REQUEST FOR COUNCIL ACTION

AGENDA SECTION: PUBLIC HEARINGS	ORIGINATING DEPT: PLANNING	ITEM NO. E-7
ITEM DESCRIPTION: <u>Land Subdivision Permit</u> (Preliminary Plat) #03-07 to be known as Stonehedge Estates Second Subdivision, by Stonehedge Land Development LLC. The Applicant is proposing to subdivide approximately 119.78 acres of land into 152 lots for single family development and 14 Outlots. The applicant is requesting a <u>Design Modification</u> #03-02 to not construct a secondary access as required in the Zoning Ordinance and Land Development Manual. The property is located north of East Circle Drive, northwest of Century High School, adjacent to Stonehedge First Sub. and Christ Our Rock Sub. and east of the Northwoods Hills Second Sub.		PREPARED BY: Mitzi A. Baker, Senior Planner

RE: Land Subdivision Permit (Preliminary Plat) #03-07 to be known as Stonehedge Estates Second Subdivision, by Stonehedge Land Development LLC. The Applicant is proposing to subdivide approximately 119.78 acres of land into 152 lots for single family development and 14 Outlots.

STONEHEDGE ESTATES
 ROCHESTER, MINNESOTA
 GENERAL DEVELOPMENT PLAN

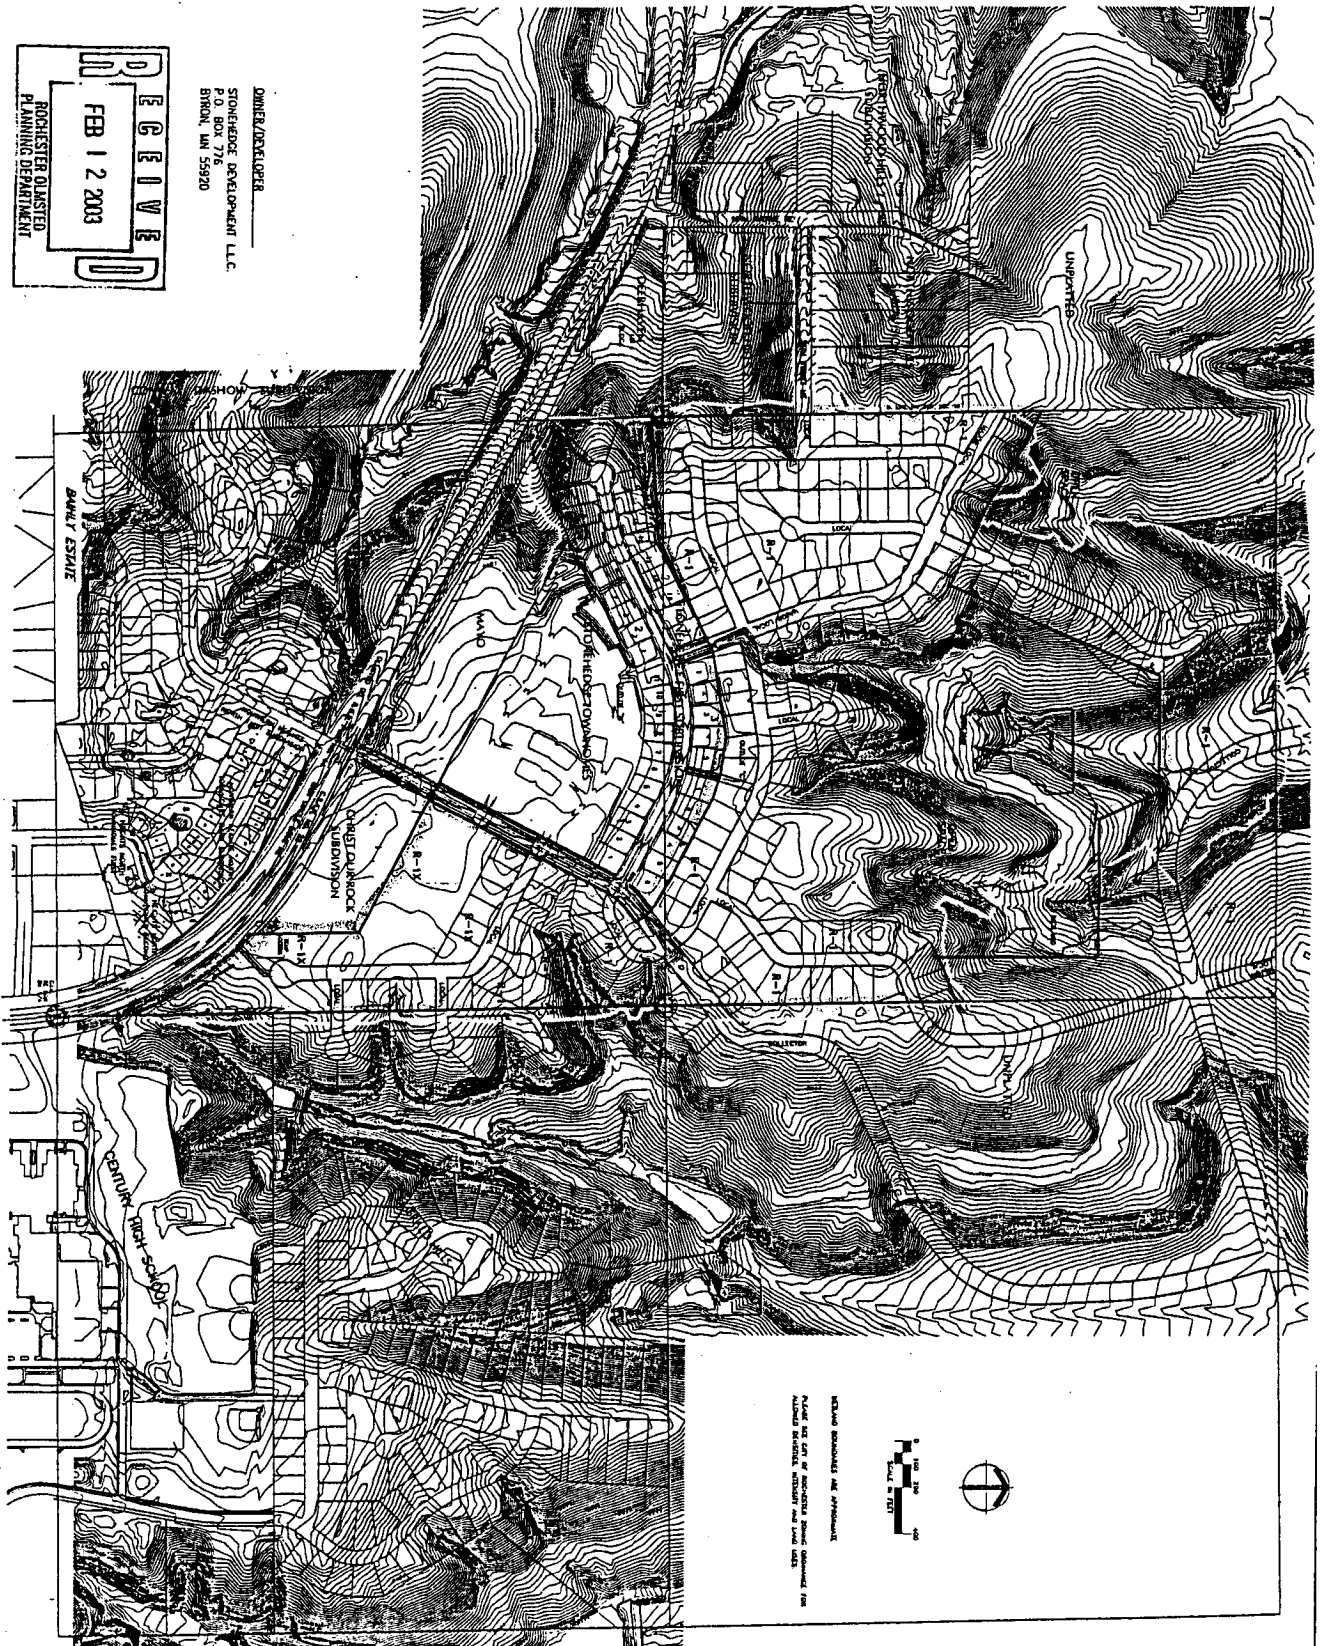
We are concerned about Design Modification #03-02 to not construct a secondary access as required in the Zoning Ordinance and Land Development Manual. We request that you deny this design modification.

The ability of fire department, ambulance and police to access Stonehedge could be impaired with only one access. All the traffic that would be generated from the proposed new development would be coming through our area of the subdivision. This could pose an additional potential hardship for us.

PRELIMINARY PLAT

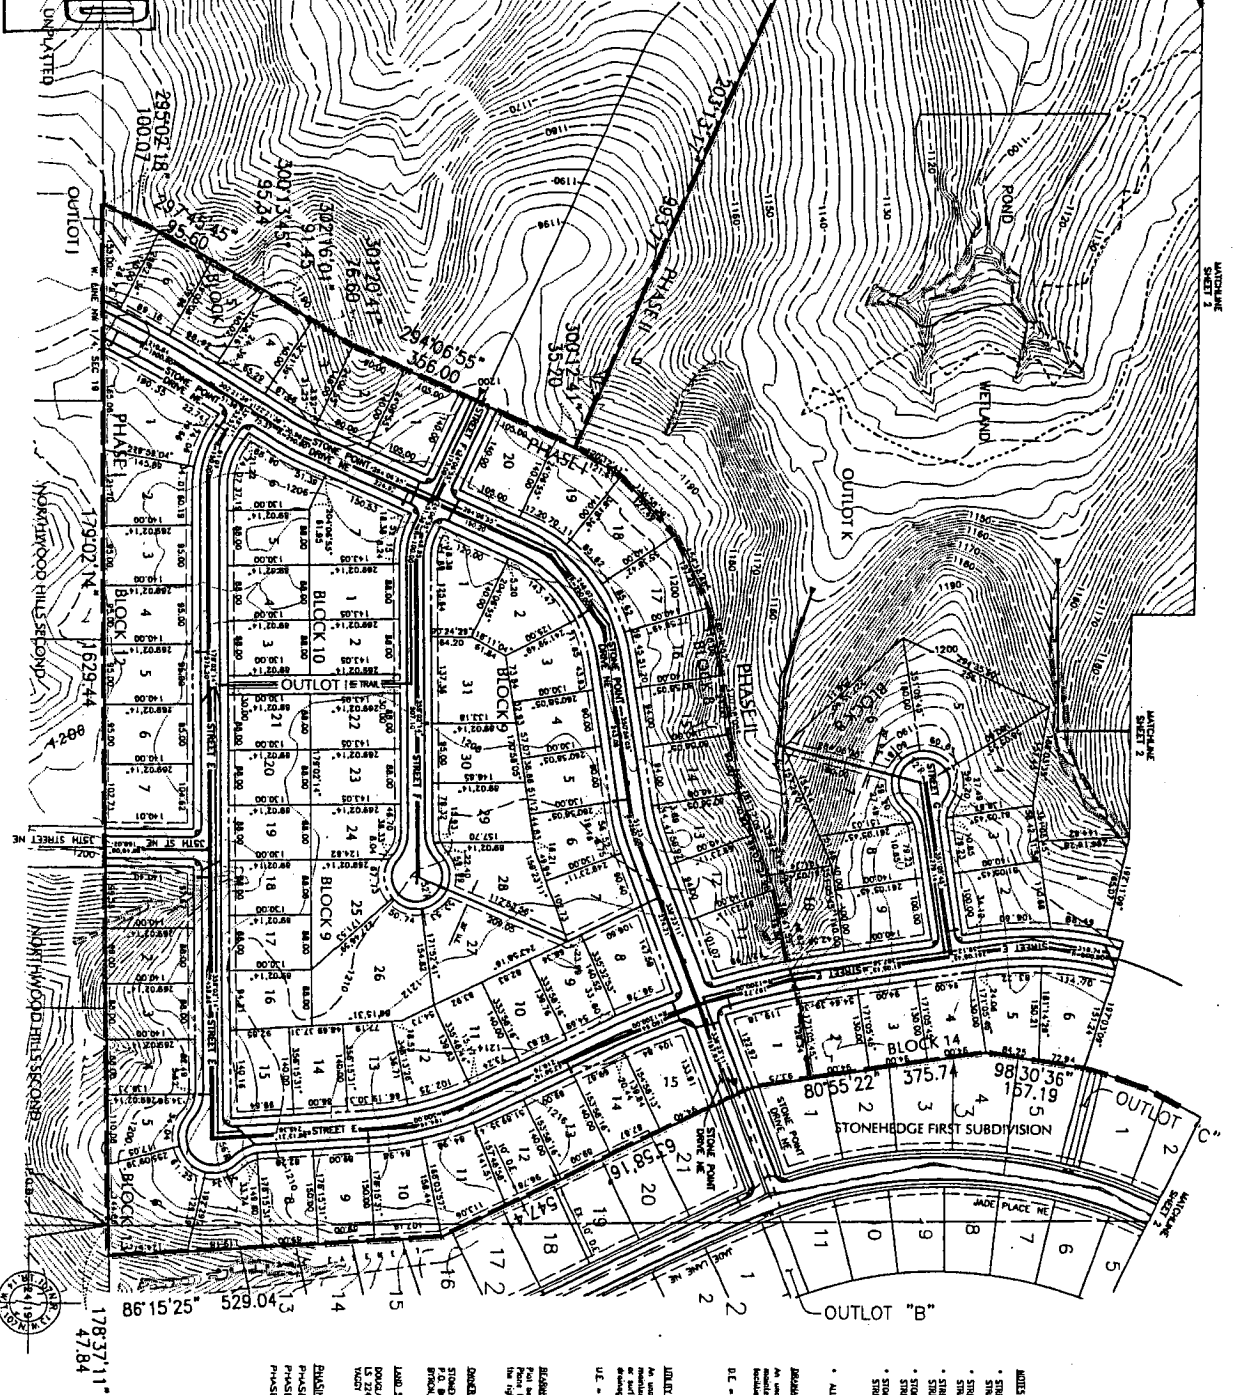
9. Preliminary Construction Plan comments will be provided separately to the Developer's Engineer.
10. The proposed "Street E" 90 degree corner in the southwest part of the plat shall have a minimum 100 foot centerline radius. In addition, the intersections of proposed "Street E" with Stonehedge Dr NE shall be at 90 degrees for a minimum of 50 feet from the intersections.

1. To provide for better networking of the water system the planned 8" loop from the Street F cul-de-sac must run between Lots 11 & 12 and 26 & 27, Block 9 along with the required 20' public utility easement.
2. Other minor revisions to the proposed water system layout are required. We have provided the applicant's engineering firm with these comments.
3. Static water pressures within this area will range from 53 to 70 PSI.

1. The preliminary plat has eight roadways illustrated as STREET A through STREET H that will need to be given a roadway name, type and directional.

9. ***Design of roadways shall be modified per February 28, 2003 comments from Rochester Public Works.***
10. ***If portions of this Plat are not serviceable with gravity flow sanitary sewer, those portions shall not proceed with Final Plat until gravity flow sanitary sewer is available, or the City approves the use of a private lift station.***

RECOMMENDATION: Coordinate all roadway designations with our office before final plat.
